Access Compliance Report

Public Rights-of-Way

(Curb Ramps)

| Intersection ID: 2480 | Main Street: CAMBRIDGE_BAY_DR | Cross Street: HEARST_CT | Location: | NW |

| ADA ID: 54D8C3F89340 | Ramp Type: PerpDiag | Initial Pass/Fail: Fail | Overall Compliance: No | Severity Score: 10 |

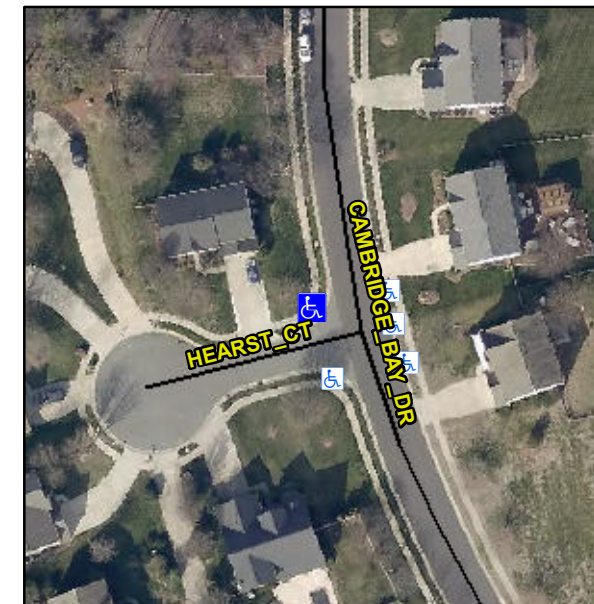
R304.5.1, R304.5.3

| Compliance | Description | Data | Compliance | Description | Data |
|------------|-----------------------|------|------------|-----------------------------|------|
| No | Ramp Width (in) | 45.0 | No | Ramp XSlope (%) | 4.4 |

Remove & Replace Curb Ramp With Two New Directional Ramps or Equivalent.
